GNRO-2017/00080

SUBJECT: Reply to Notice of Violation – Clarification of Information
Grand Gulf Nuclear Station, Unit 1
Docket No. 50-416
License No. NPF-29

REFERENCES: NRC Radiation Protection Inspection Report 05000416/2017012 and Notice of
Violation August 22, 2017
Reply to Notice of Violation dated September 21, 2017
Docket No. 50-416
License No. NPF-29

Reply to Notice of Violation – Clarification of Information

Main Steam Line Radiation Monitors

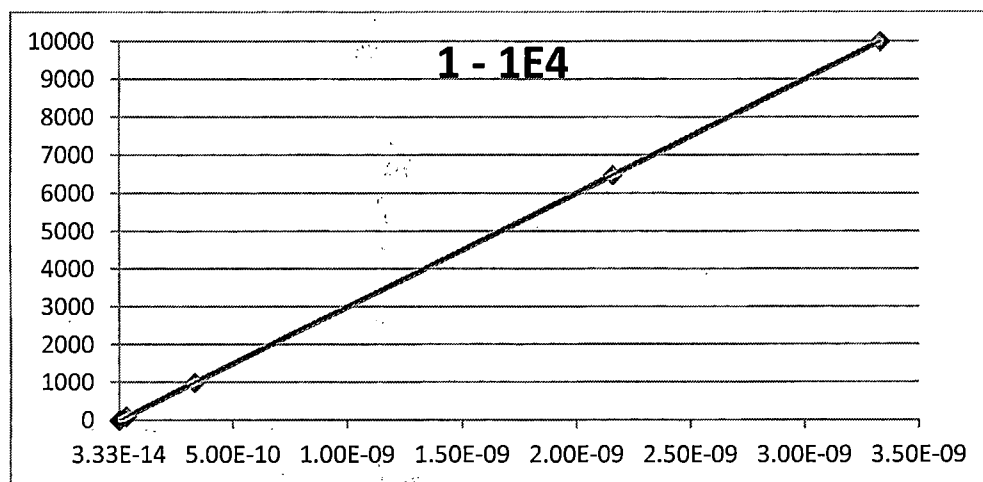
6. When two points are used to establish response to a range of radiation levels, the linear relationship of the detected points needs to be stated and supported by evidence.

Linearity applies to the Main Steam Line Monitors only. Two radiation source calibration data points are plotted on the electronic calibration results line.

The CALIBRATE function of the NUMAC Logarithmic Radiation Monitor checks the internal calibration sources to external standards and allows the user to initiate an internal and automatic calibration sequence. The plant surveillance procedure 06-IC-1D17-R-1002 validates that the radiation monitors are indicating within the acceptable ranges. The radiation calibration section of 06-IC-1D17-R-1002 validates the detector response is within the allowable tolerances.
